## DECISION OF THE PLANNING COMMISSION

**MINOR COMPREHENSIVE PLAN MAP AMENDMENT / ZONE CHANGE /  
CONDITIONAL USE PERMIT / URBAN GROWTH PRELIMINARY  
DECLARATION / CLASS 3 SITE PLAN REVIEW / CLASS 2 ADJUSTMENT /  
CLASS 2 DRIVEWAY APPROACH PERMIT / CLASS 1 DESIGN REVIEW CASE  
NO.: CPC-ZC-CU-UGA-SPR-ADJ-DAP-DR23-01**

**SUMMARY:** Proposed 396-unit multiple family residential development with associated off-street parking, common open space, and site improvements.

**SDR3**

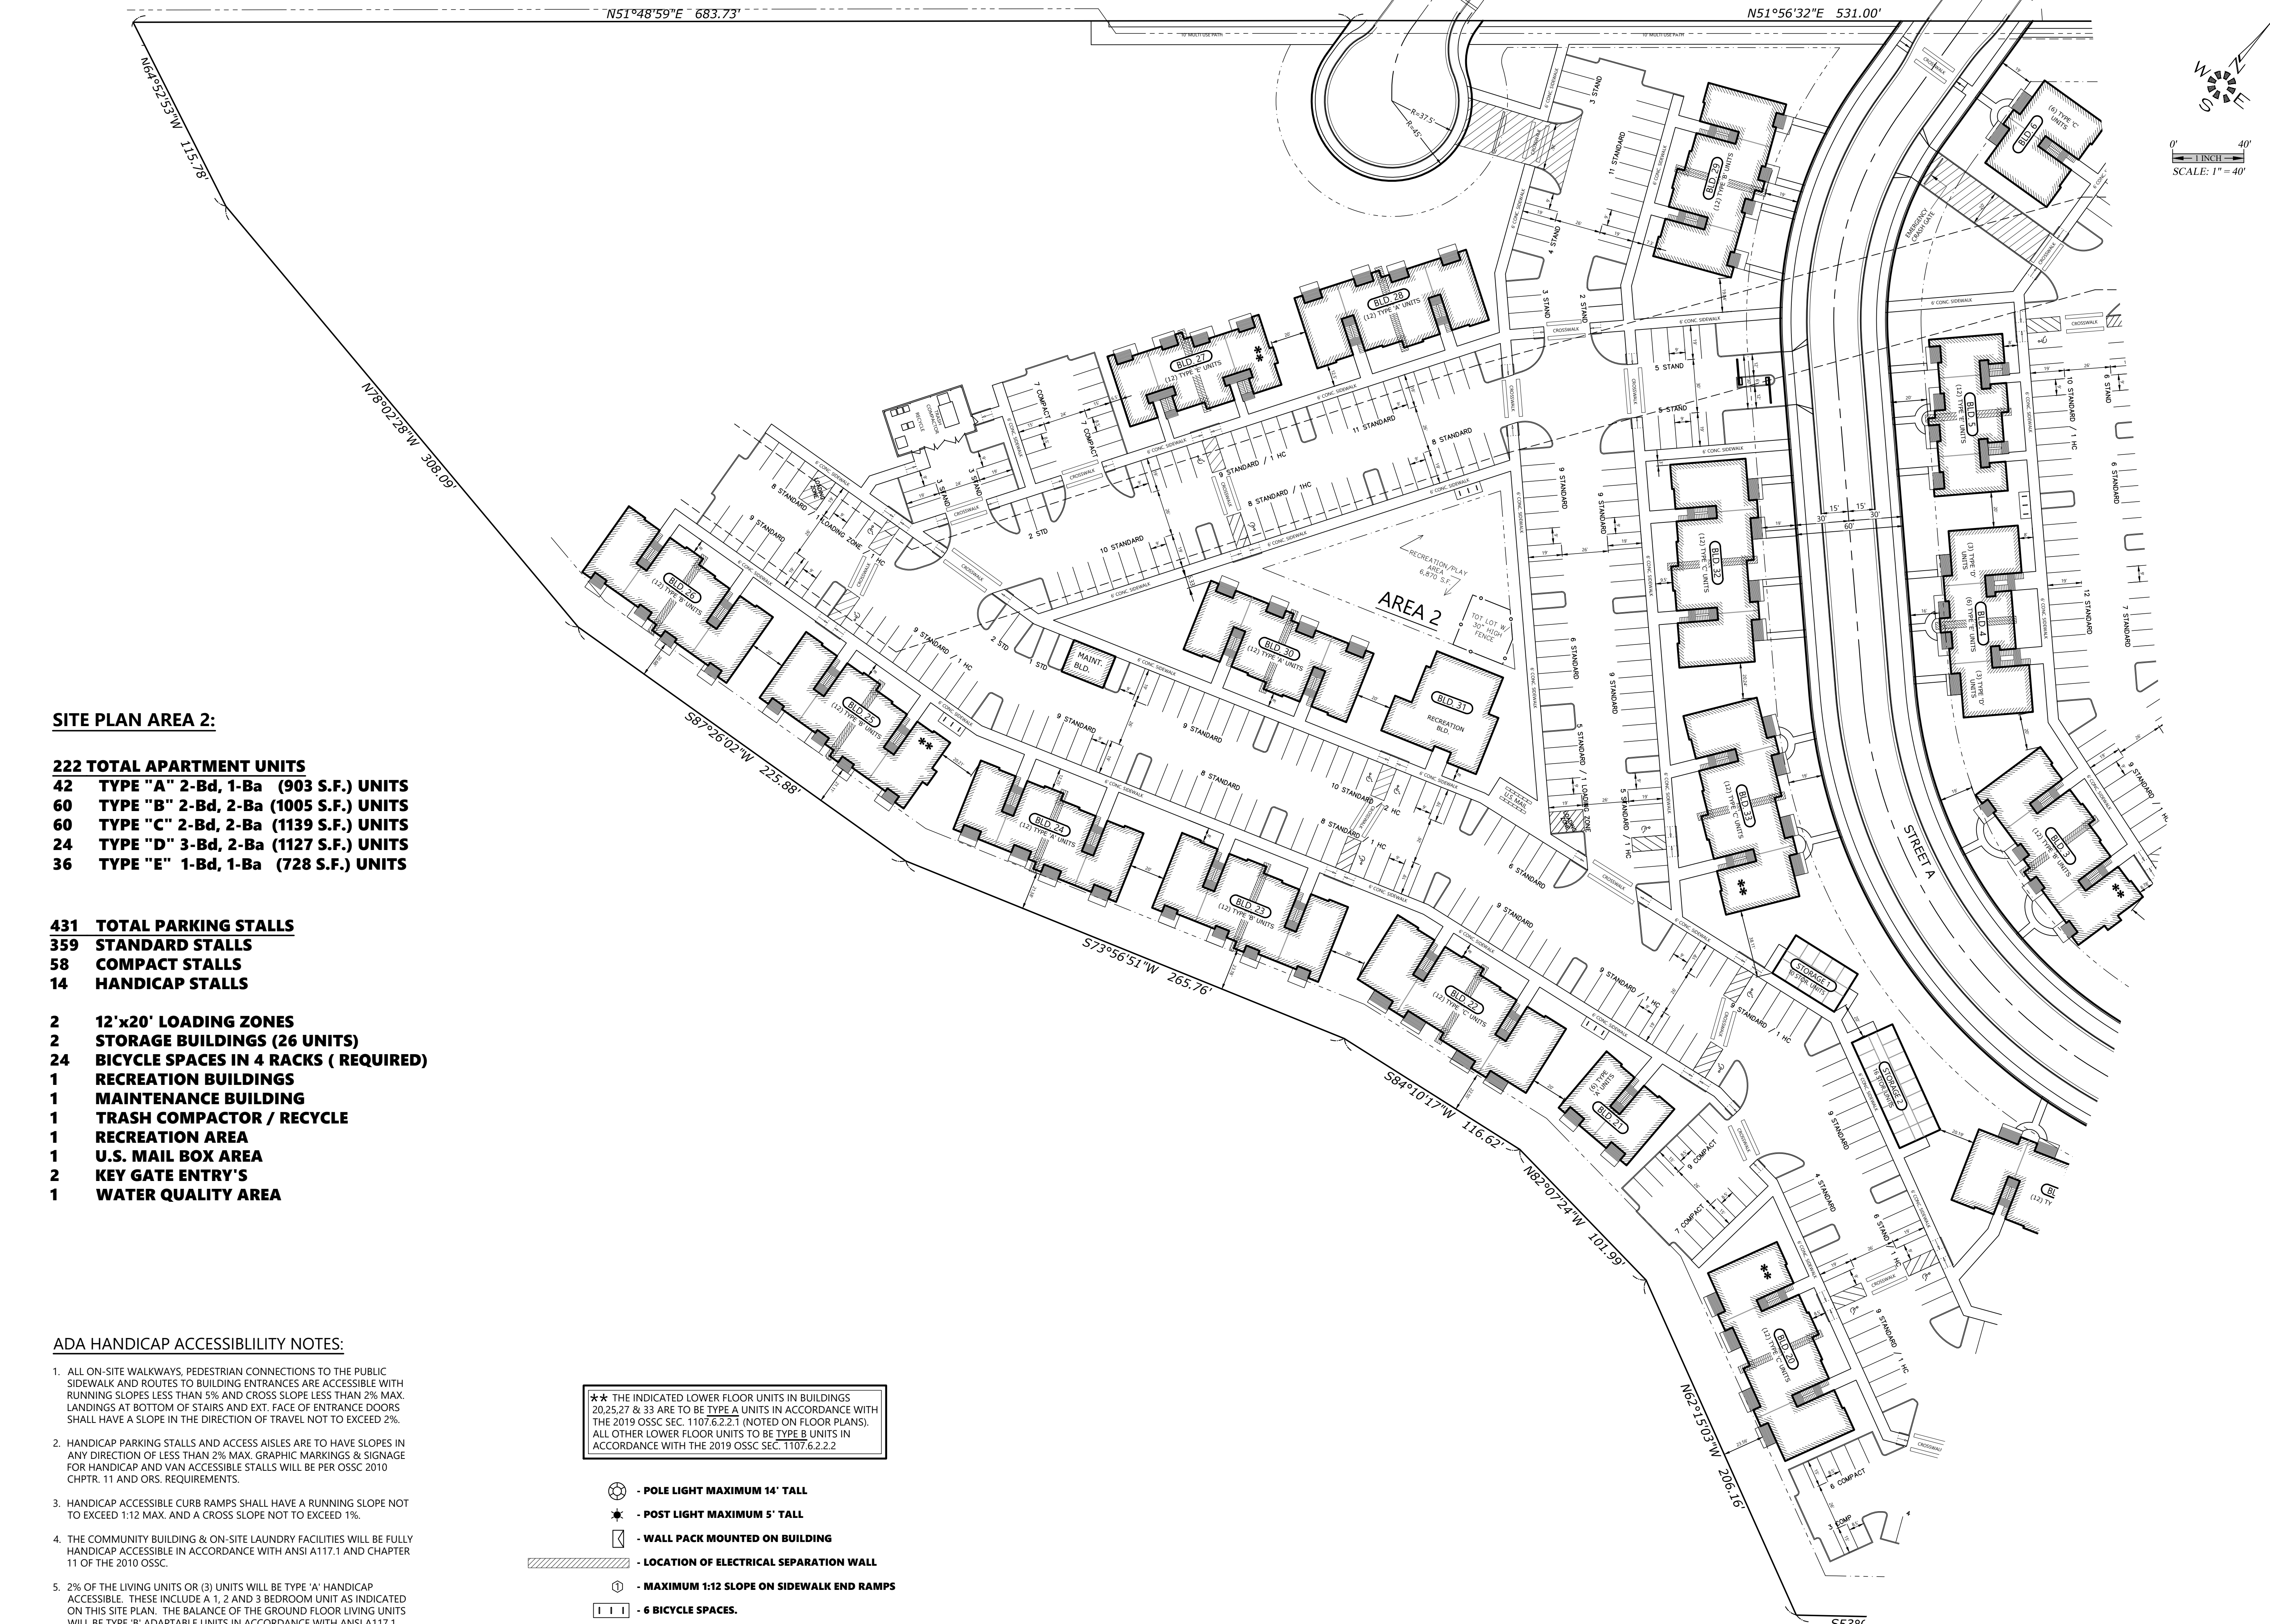
- 4) A Class 3 Site Plan Review;
- 5) Class 2 Adjustment to:
  - a) Allow parking to be located between Building 29 and the proposed cul-de-sac of Seattle Slew Drive SE (SRC 702.020(e)(3));

- Condition 5:** The off-street parking area located immediately to the north of Building 9 shall be reconfigured to provide a minimum 15-foot set adjacent to the eastern property line.

JOB NO. 7314  
 DATE 06/25/22  
 DESIGN BY AL/NP  
 CHECKED BY AL  
 SHEET **LS-2**

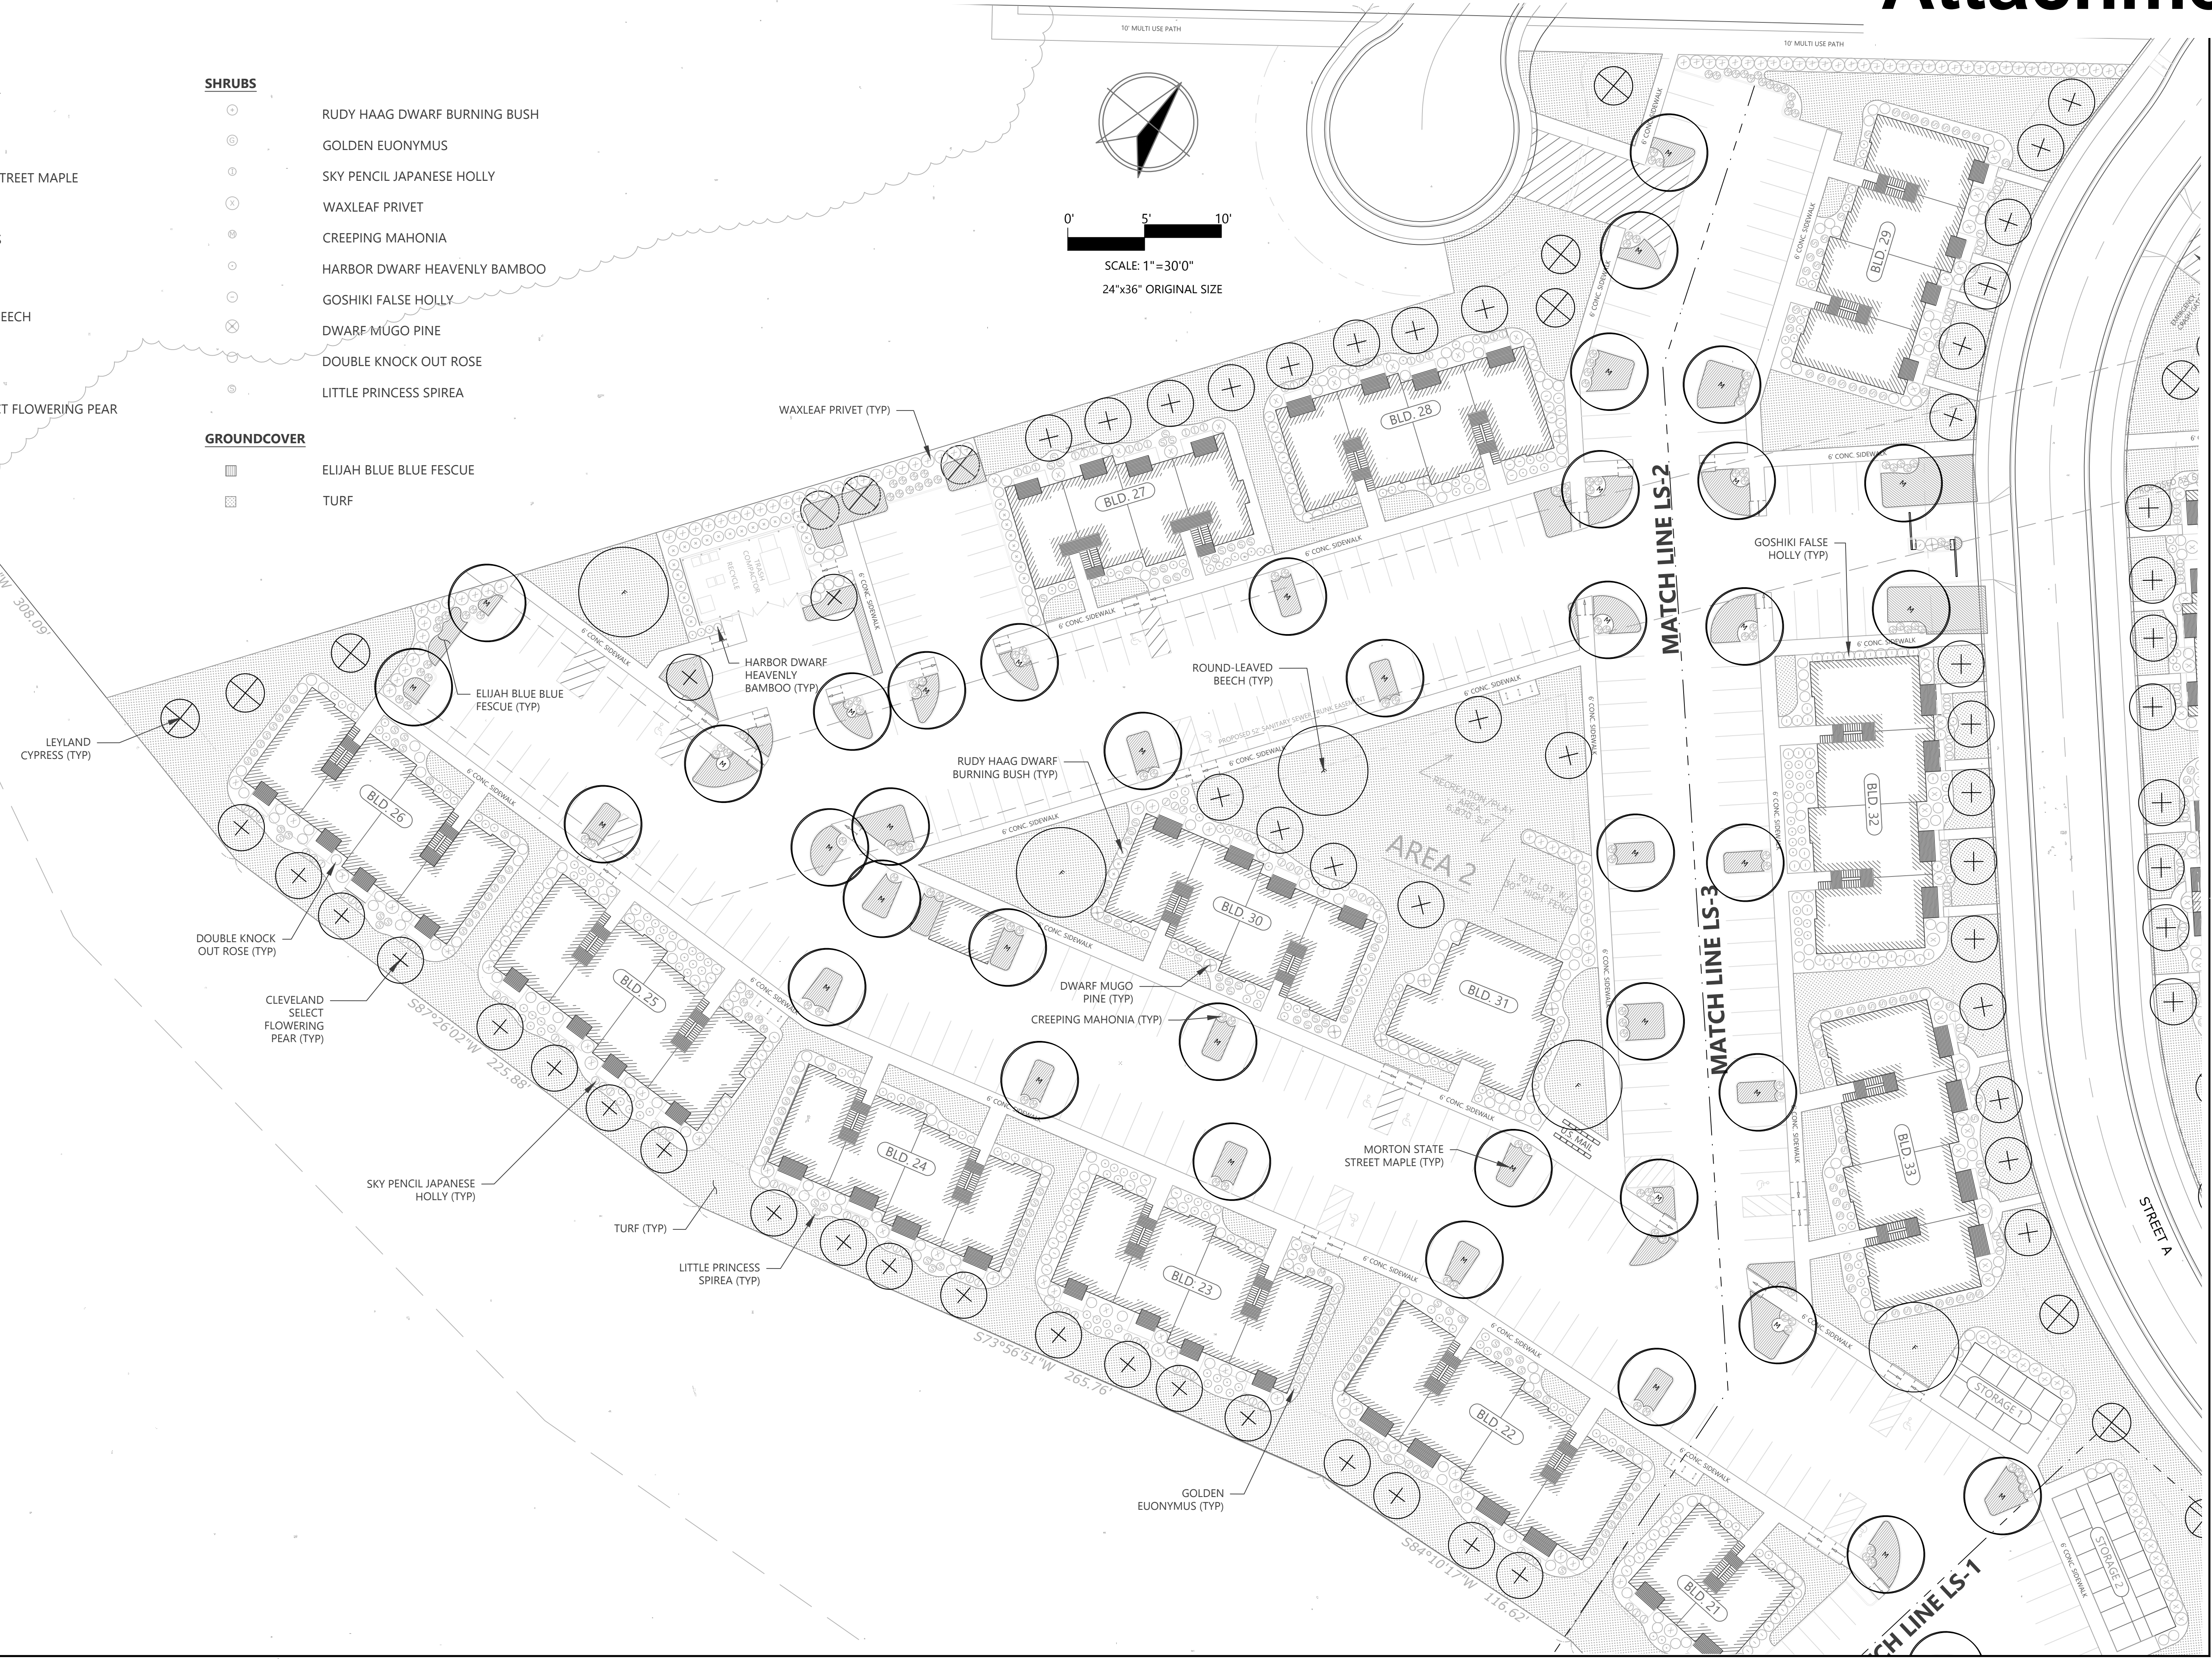
- Condition 34:** The Leyland Cypress trees identified on the landscape plan shall be replaced with evergreen species on the City's approved street tree list.
